3 May 2016

Our Ref: P15-190

**RE: MODIFICATION REQUEST FOR SHEPHERDS BAY CONCEPT PLAN MP09_0216
MOD2 - RESPONSE TO SUBMISSIONS (STAGE 2/3 & 8/9)**

Figure 1: Extract of Community Facility comparison plan (source: Turner)

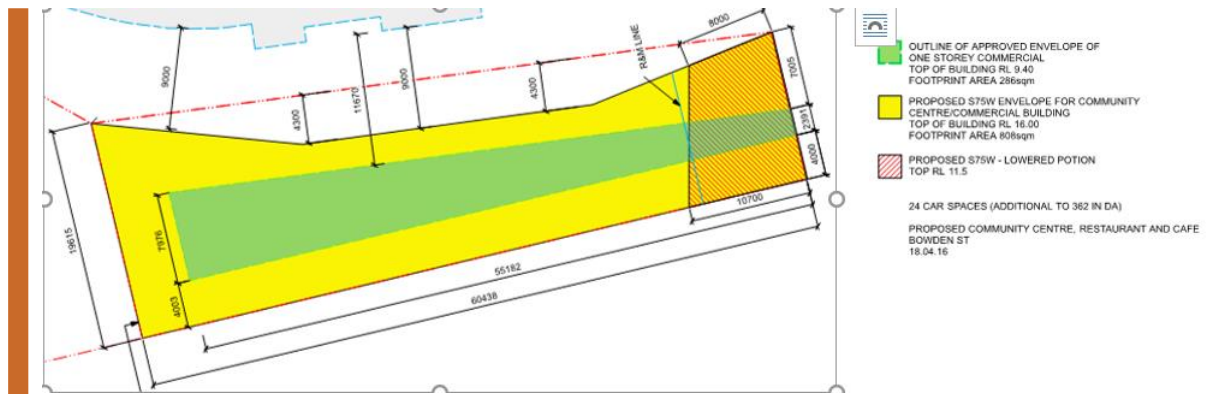
As sought by item 13 of DPE's correspondence, a comparison plan is provided at **Appendix C** (an extract of the plan is provided on the following page). The plan provides a comparison between the approved building on the site which is proposed to be occupied by the Community Facility, and the proposed envelope for the said site. The most obvious modifications to the envelope include a larger footprint (i.e. 286m² v 808m²), and a taller envelope (i.e. RL 9.40 v RL 16.00).

The amendments to the previously approved building envelope are required to:

- Satisfy the spatial requirements of Council as per the signed Deed of Agreement between Ryde Council and Holdmark.
- Comply with the requested requirements of VIVA Energy who are responsible for the pipeline which is immediately adjacent the proposed Community Facility. Correspondence from VIVA Energy outlining the said requirements is provided at **Appendix D**.

Figure 2: Extract of architectural plans demonstrating solar access (source: Turner)

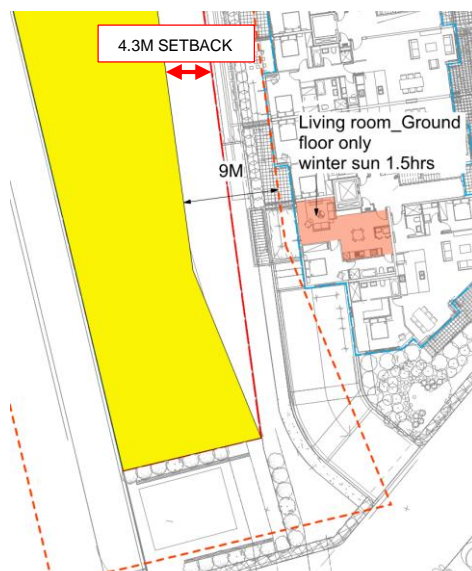
The facility's deeper and taller envelope may reduce solar access to the residential flat building (RFB) currently under construction immediately to the east of the subject site (i.e. No. 146 Bowden Street).

In the first instance, it should be noted that all those rooms, at 146 Bowden Street directly opposite the proposed Community Facility are all bedrooms, with the exception of one room which is a living room (as noted in the plan extract below). Further, most openings on that elevation of 146 Bowden Street (i.e. western elevation) which face the proposed Community Facility include privacy screens. The screens would compromise solar access to the openings on the western elevation of 146 Bowden Street by varying degrees, irrespective of the size of the proposed Community Facility.

Turner Architects have produced solar access diagrams, included at **Appendix E**, demonstrating the extent of solar access to 146 Bowden Street as a result of the proposed Community Facility. As recommended by the ADG, all but one of the windows on the western elevation of 146 Bowden Street (i.e. facing the proposed Community Facility), receive at least 2 hours of direct sunlight between 9am and 3pm at mid-winter. The window which would not achieve the recommended 2 hours, is on the ground floor and relates to a living room. This window achieves 1.5 hours access to sun light between 9am and 3pm at mid-winter. This is a minor deviation from the ADG recommendation.

Figure 5: Extract of architectural plans demonstrating substantial ADG compliant separation (source: Turner)

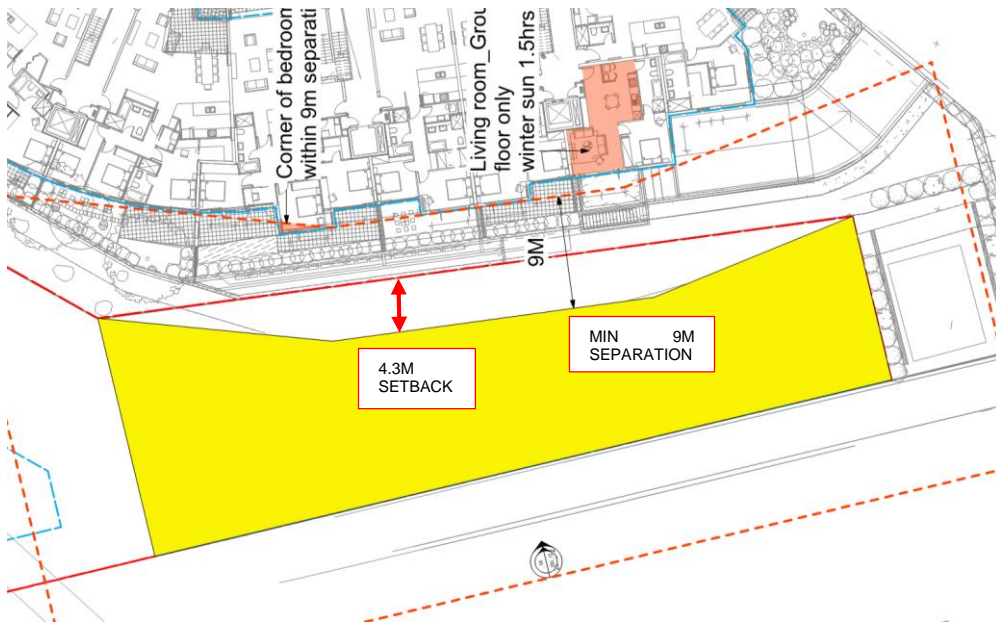
There may be perceived adverse privacy impacts, particularly as a result of a taller Community Facility, to the RFBs at 146 Bowden Street and 141 - 143 Bowden Street.

Finally, and despite the proposed Community Facility's wider footprint, substantial compliance is achieved with the building-to-building separation recommendations provided by Objective 3F-1 of the ADG. That is, for developments up to 25 metres in height, the ADG recommends 4.5m side boundary setbacks for non-habitable rooms. The vast majority of the proposed Community Facility is setback 4.3 metres from the side boundary shared with 146 Bowden Street as demonstrated in the extract of the architectural plans on the following page.
